Response to Request for Additional Information – ANP-10279
“U.S. EPR Human Factors Engineering Program Topical Report”
(TAC No. MD4252)

HFE Process

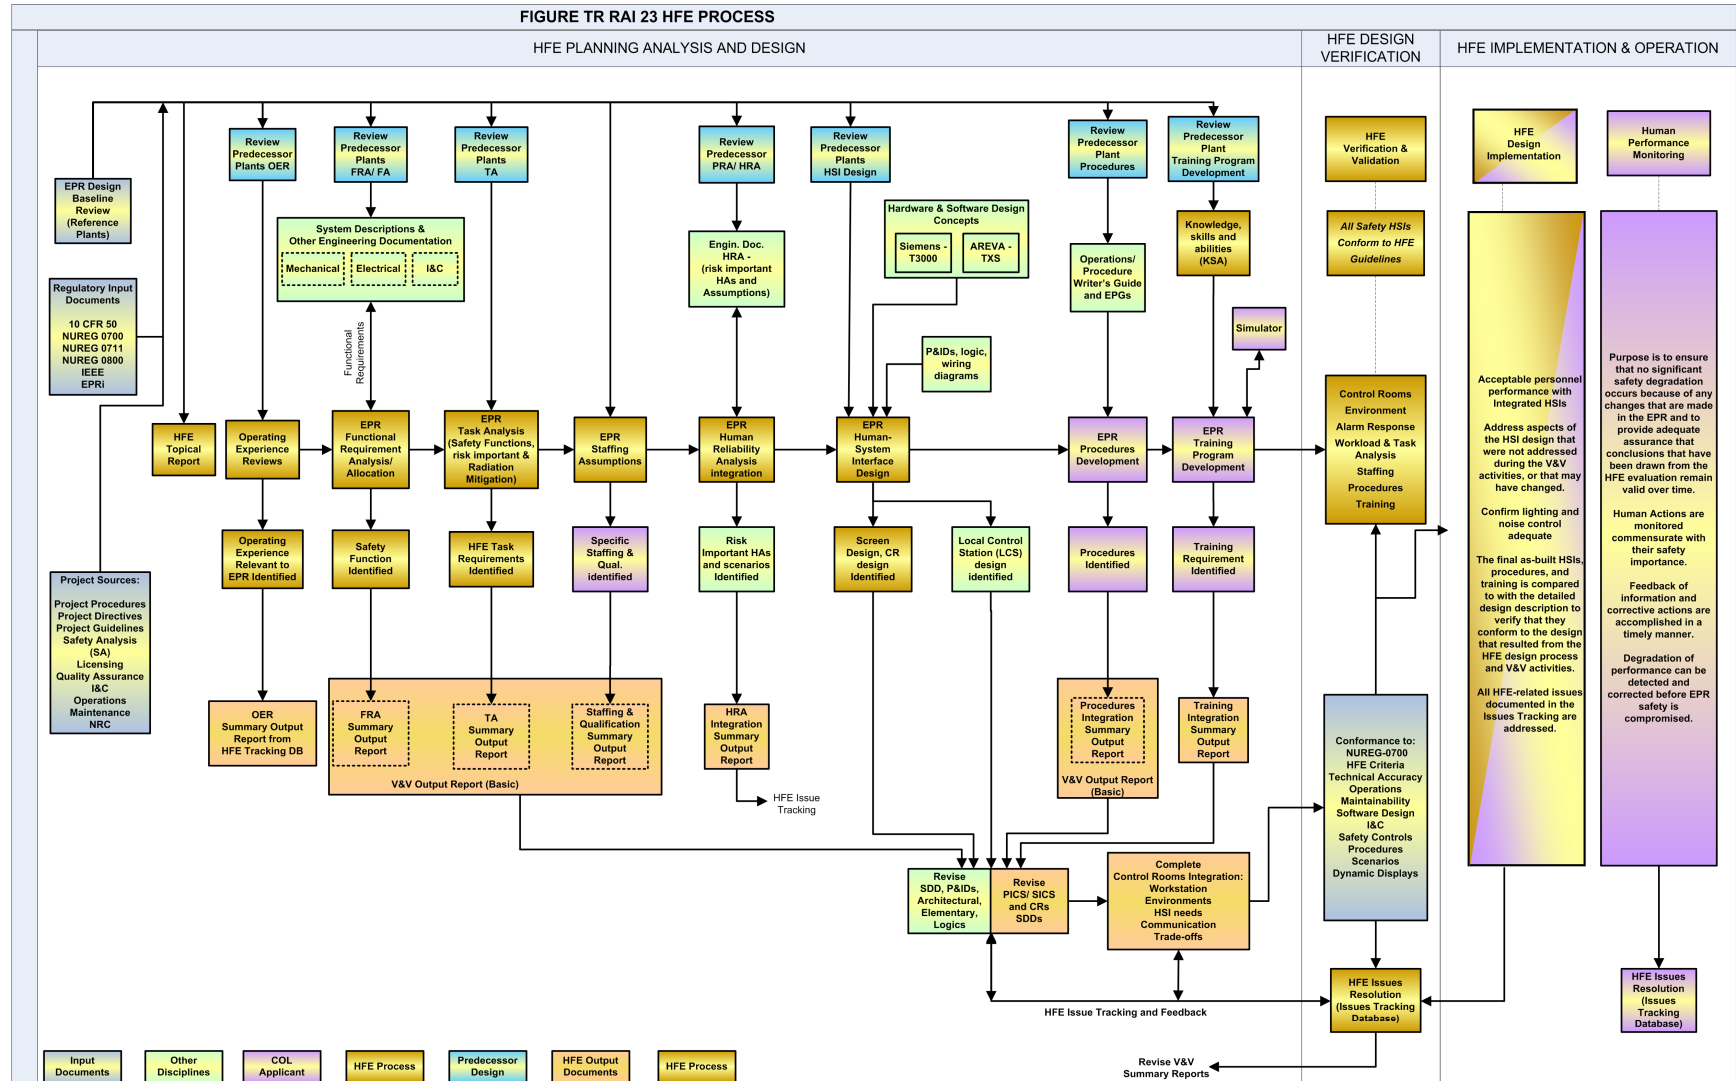
RAI-23: New Section 5.4.2.1.2 states that the Program Manager for HFE is responsible for integration of the HSI with the overall plant design, but the report does not specify what that integration involves. Please identify the inputs from other plant design activities to the HFE program and the outputs from the HFE program to other plant design activities.

Please see the attached figure, Figure “TR RAI 23—HFE Process” for flow of work. It is similar to U.S. FSAR Tier 2, Section 18.1, Figure 18.1-1— “HFE Program Milestones” and Figure 18.1-2— “HFE Design Control Process”, but shows more ties to other engineering disciplines.

Updated Control Room Layout

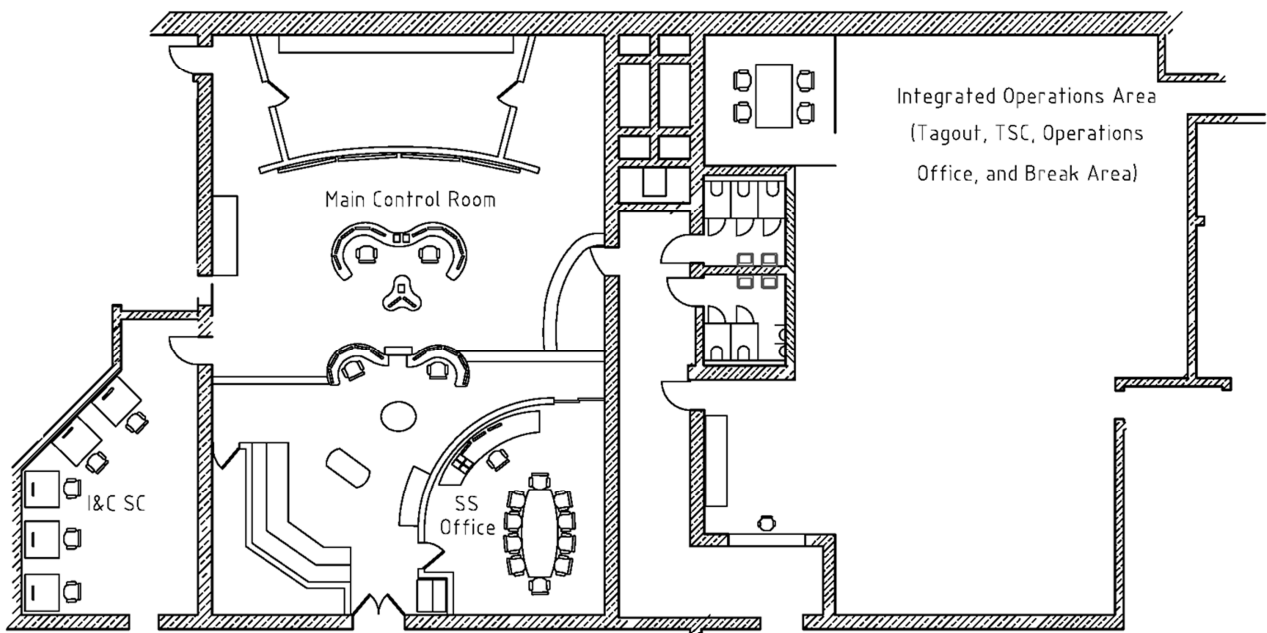
RAI-39: New Clarify displays available to the SS. Section 4.1.1 describes how the shift supervisors monitor plant activities and note they may use the auxiliary workstation in the MCR if not in use. Explain why the SS does not have a dedicated workstation available for their use in monitoring the plant and maintaining their overall situation awareness.

The updated control room layout drawing shown below replaces Figure 3.1-1 in ANP-10279.

The shift supervisor (SS) will normally use a dedicated Process Information and Control System (PICS) workstation located in the SS office. Administrative rules limit control of plant functions from this PICS workstation, though it is capable of displaying the same plant monitoring information as any other PICS workstations. To maintain overall situation awareness, the SS office offers a direct line of sight to the plant overview panels (POP). In addition to the PICS workstation, the SS office contains various types of communication equipment. In the event that the SS finds need of direct communication with the control room operators while continuing to monitor plant status, the auxiliary workstation is provided. If the licensee dedicates a separate shift technical advisor role, the auxiliary workstation is intended for that use.
